SERVICETEKNOTES

TABLE OF CONTENTS

FG502 FET (Q200, Q202) ORIENTATION

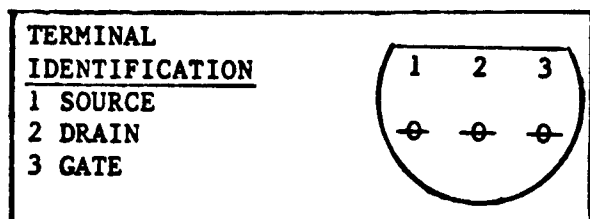
The question has been raised about terminal identification on FET's with P/N 151-1042-00. This in turn causes confusion when replacing Q200 and Q202 in the FG502 Triangle Generator circuit. Below is a diagram that identifies the terminals on this particular case style.

Note: Bottom view of component is indicated.

670A SELECTABLE PARTSREF: 670A Instruction Manual,
070-2201-01

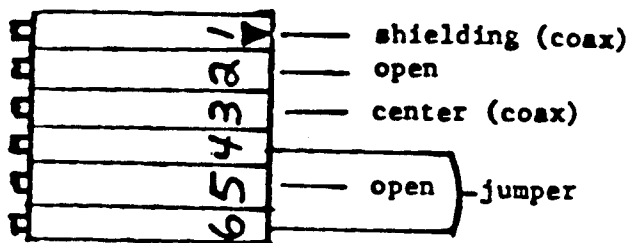
One of the capacitors listed in table 6-4 of the 670A manual, as a selectable alternative for C5240, is no longer available.

P/N 285-0532-00 was a 0.15 ufd -2% + 20% 400 V cap.

A suitable replacement part for this application is 285-1227-00, a 0.15 ufd +/- 2% 400 V cap.

7612D CIRCUIT BOARD DISCREPANCYREF: 7612D Instruction Manual
(070-2387-00)
Parts Location Diagram for the
A26 Deflection Amplifier
Circuit Board

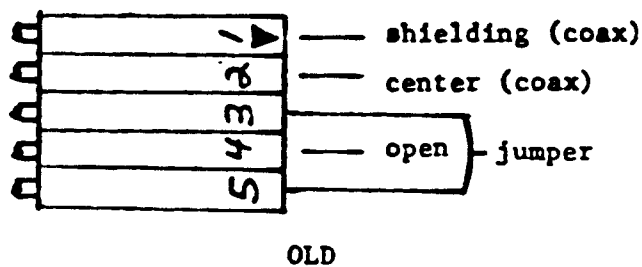
Connector A26 J918 was changed when the circuit board went from a 670-4941-04 to the 670-4941-05 version. The connector on cable P918 will need to be modified to be compatible with the -05 version circuit board. The illustration below reflects these changes. P/N 352-0164-00 (Black plastic connector, 6-pin) is needed to make this change.

1741 VECTOR JITTER WITH TAPE RECORDER

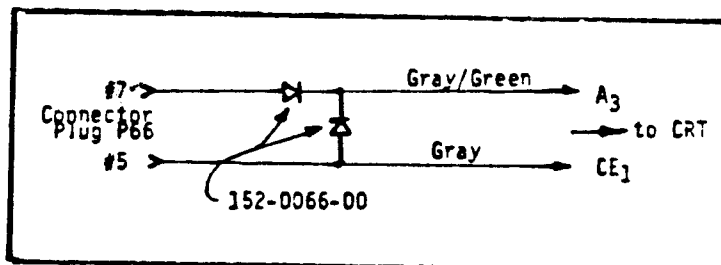
For the 1741 user who would rather see a jitter-free vector display, the 1741 can be made to average the bursts similar to the 521's or 1421's.

To accomplish this change, P728 (Schematic 6) can be put in the "1740" position. This should help in all but extreme cases of Burst Phase jitter.
